**Sydney Development Control Plan 2012
55 Pitt Street, Sydney amendment**

Sydney Development Control Plan 2012 – 55 Pitt Street, Sydney

March 2020

Figure 6.7A

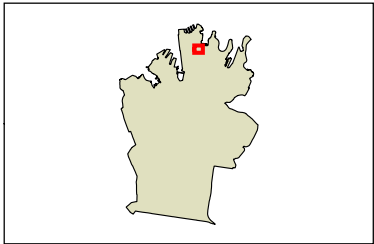
- (1) *Where required to be provided, new streets, lanes and through-site links are to be provided in the locations identified in Figure 6.7 Public domain plan for blocks 1, 2 and 3 and in Figure 6.7A Public domain plan Option B for block 4 and block 5, and are to be designed and constructed in accordance with Figure 6.8 Street, lanes and through-site links for blocks, 1, 2 and 3 and in Figure 6.8A Streets, lanes and through-site links Option B for block 4 and block 5.*
- (2) *Ensure the design of the laneway network and square integrates with the ground floor uses of adjoining buildings and provides opportunities for external leisure activities.*

- (16) *Through-site links are to have a clear height up to the levels indicated on Figures 6.7 and 6.7A Public domain plan.*
- (17) Enhance pedestrian amenity by extended and widening Queens Court to become an accessible through-site link identified as 1F on Figure 6.9 and 6.9A Public domain principles plan.

- (1) *Public plazas are to be provided as shown generally on Figure 6.7A Public domain plan Option B.*
- (2) *The combined area of the public plazas, outlined in red on Figure 6.9A Public Domain principles plan Option B, shall be a minimum of 1,800sqm.*

Replace Figure 6.7A as shown attached

Figure 6.9A

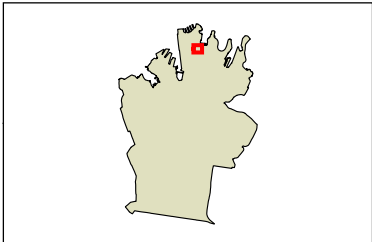
- (13) *For a development of block 4, integrate the George St plaza, marked G on Figure 6.9A Public domain principles plan, with the publicly accessible area on the northern part of 188-194A George Street.*

- (3) *The new public plaza to George Street, marked G on figure 6.9A Public Domain principles plan Option B, is to:*
 - (a) *have direct access from George Street;*

- (g) *incorporate high quality public art.*
- (4) *The new public plaza at the Pitt Street level, marked P on figure 6.9A Public domain principles plan Option B is to:*

Replace Figure 6.9A as shown attached

Figure 6.10A

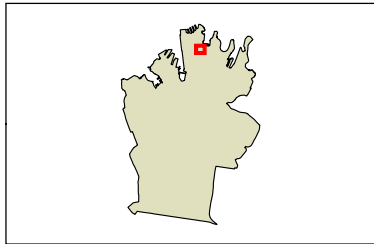
- (1) Development must not exceed the maximum height in metres for the land as shown in Figure 6.10 Alternative heights for blocks 1, 2 and 3 and in Figure 6.10A Alternative heights for option B for block 4 and block 5.
- (2) Encourage a variety of built form options within development blocks 1, 2, 3, and 4 and 5. The site area of each development block may increase with the addition of one or more optional additions A, B, or C as indicated on Figure 6.11 APDG site development blocks 1, 2 and 3 and Figure 6.11A APDG site development blocks Option B.

- (i) Pitt Street – 6m at the northeast corner of the tower, transitioning to 4m at the southeast corner of the tower;
- (ii) Underwood Street – 3m at the western corner of the tower, stepping to 4m at the eastern corner of the tower; and
- (iii) Queens Court (future through-site link) – 1m above RL 47.7m as shown in figure 6.10A Alternative heights Option B.

- (5) *For block 4 introduce a new commercial tower on the eastern side of block 4 as identified in Figure 6.10A Alternative heights Option B.*
- (5A) For block 5 introduce a new commercial tower on the eastern side of block 5 as identified in Figure 6.10A Alternative heights Option B.

(11) For block 5, the new commercial tower shall include an allowance for façade articulation equivalent to 1% of the building envelope established in Figure 6.10A Alternative Heights Option B.

(c) Any additional floor space pursued for a building demonstrating design excellence under clause 6.21(7)(b), is to be accommodated within the building envelope shown in Figure 6.10A Alternative Heights Option B.

Replace Figure 6.10A as shown attached

Figure 6.11A

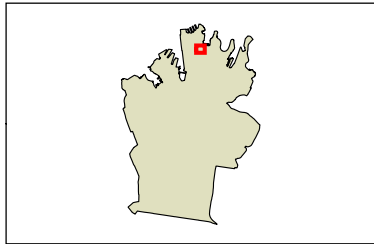
(a) An invited architectural design competition is to be undertaken in accordance with clause 6.21 of Sydney LEP 2012 for the entire site identified as block 5 in Figure 6.11A – APDG Site – Development blocks Option B.

Replace Figure 6.11A as shown attached

Figure 6.12A

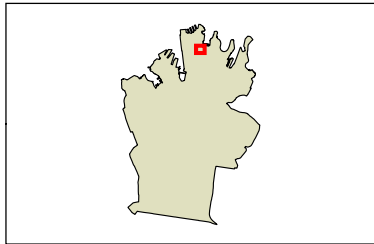
- (1) For development of blocks 1,2 and 3, active frontages are to be provided in the locations nominated on the Active frontages map.
- (2) For development of block 4 and block 5, active frontages are to be provided in the locations nominated generally on Figure 6.12A Active frontages option B.

Replace Figure 6.12A as shown attached

Figure 6.13A

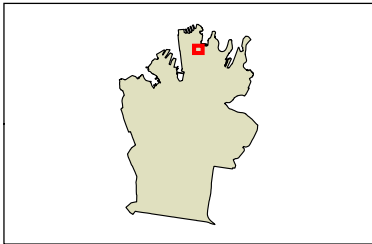
- (1) The street frontage height of a building is not to exceed the maximum height shown for land on Figure 6.13 Building frontage height for blocks 1, 2 and 3 and as shown on Figure 6.13A Building frontage height Option B for block 4 and block 5.
- (2) The maximum width of an elevation above the street frontage height of buildings, as shown in Figure 6.13, is to be 35% of the total height of the building, excluding curved facades where the change in tangent across the façade is greater than 60 degrees.

- (3) Ensure a minimum of 95% of each of the building frontages are built to the alignment of the public domain to the height shown on Figure 6.13 Street frontage height in metres for blocks 1, 2 and 3 and shown on Figure 6.13A Street frontage height in metres for Option B for block 4 and block 5.

Replace Figure 6.13A as shown attached

Figure 6.14A

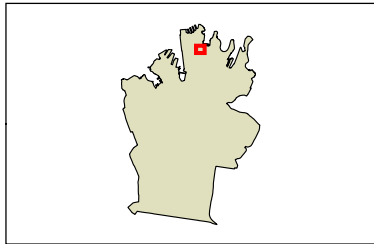
- (4) Provide setbacks above the street-wall in accordance with Figure 6.14 Setbacks above the street frontage height for blocks 1, 2, and 3 and on Figure 6.14A Setbacks above the street frontage height Option B for block 4 and block 5.

Replace Figure 6.14A as shown attached

Figure 6.15A

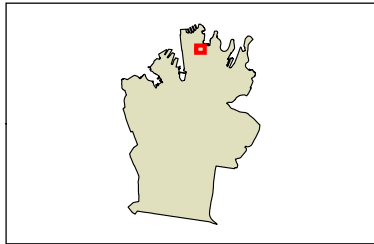
- (1) *Vehicle and service entry points are to be consistent with Figure 6.15 Vehicular access plan for blocks 1, 2 and 3 and Figure 6.15A Vehicular access plan Option B for block 4 and 5.*
- (2) *One way vehicular access provided from the new north-sound lane to George Street identified as 'A' and 'B' on Figure 6.15 Vehicular access plan for blocks 1, 2 and 3 is short term only.*
- (3) *Provide shared basement access between developments to minimise vehicular movements on lanes.*
- (4) *Loading docks are not permitted on George, Pitt or Alfred Streets or on the new public square frontage*
- (5) *Above ground parking is not permitted.*

Replace Figure 6.15A as shown attached

Figure 6.16A

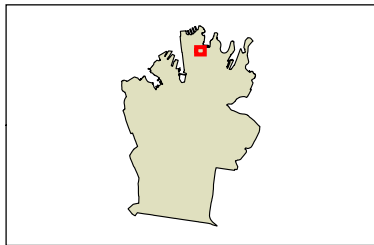
(a) *An invited architectural design competition for a building on the land shown as Area A on Figure 16.6A Design Excellence Option B;*

(b) *The preparation of design alternatives on a competitive basis for a building on the land shown as Area B on Figure 16.6A Design Excellence Option B.*

(e) *To achieve a whole of site design excellence, the architectural design processes for the land shown as Area A and Area B on Figure 6.16A are to be run concurrently.*

Figure 6.18a
 North-west View
 Development
 Control Envelope
 – 55 Pitt Street

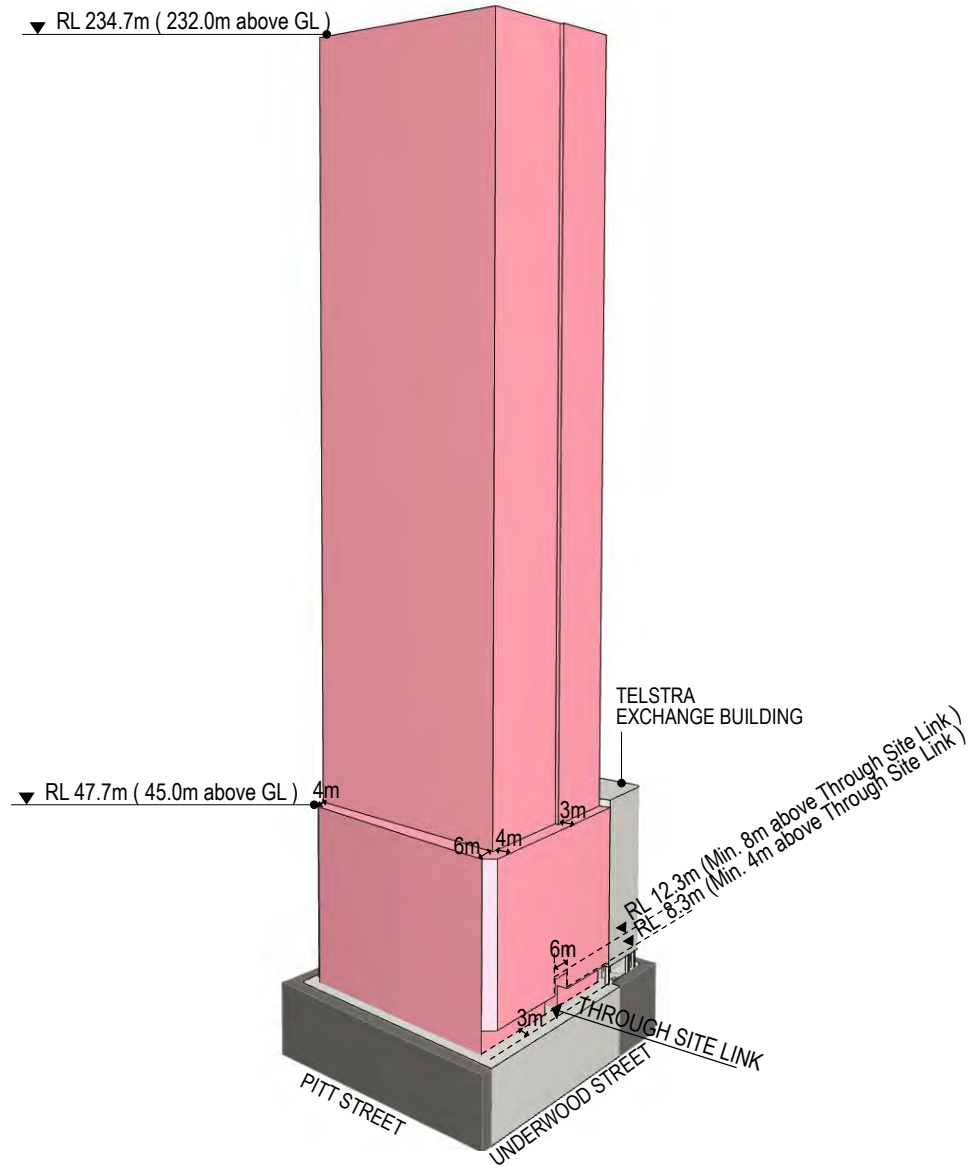
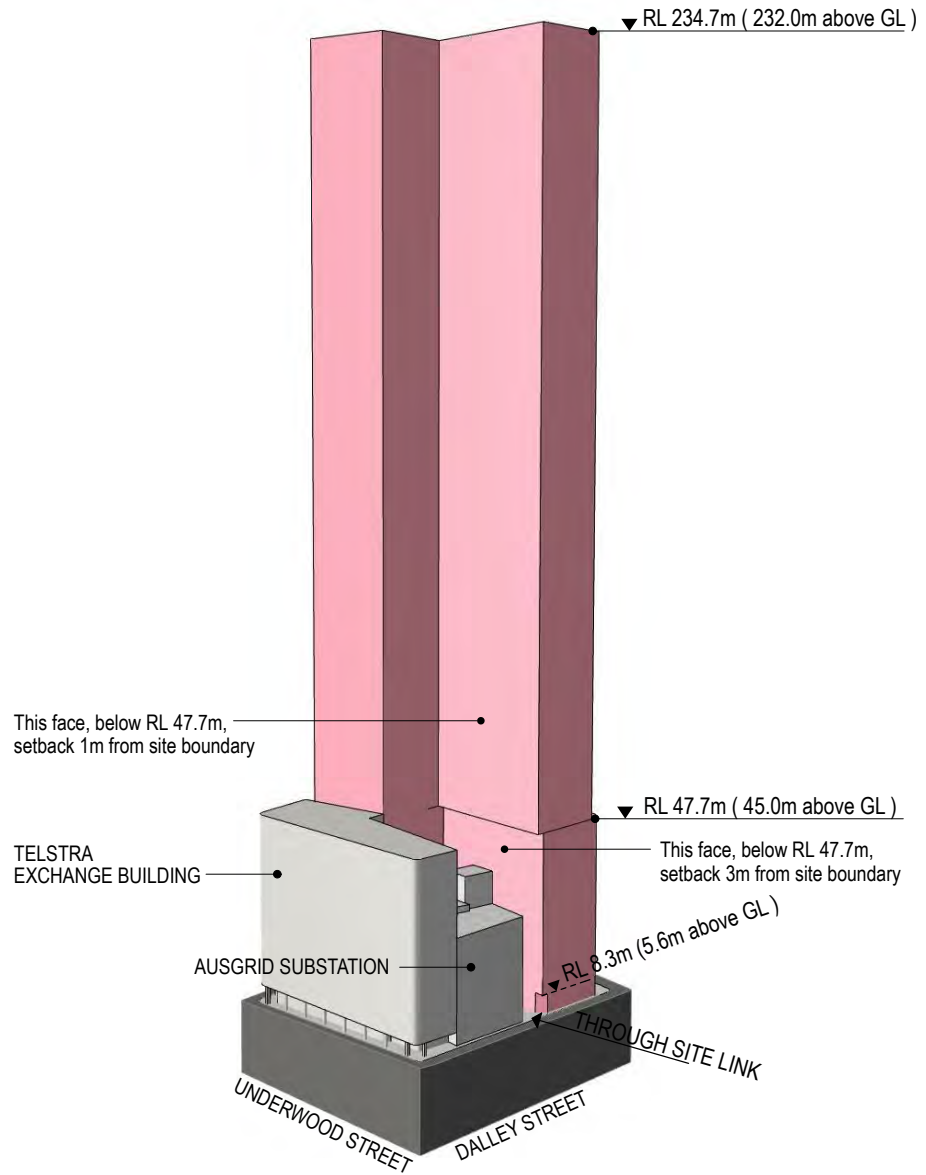
- (f) reduce flooding impacts, be accessible and maintain clear sight lines from each end;
 - (g) include ground level as shown in Figure 6.19 to prevent a 100 year flood event passing through to Underwood Street;

Inset new Figure – Development Control Envelope – 55 Pitt Street
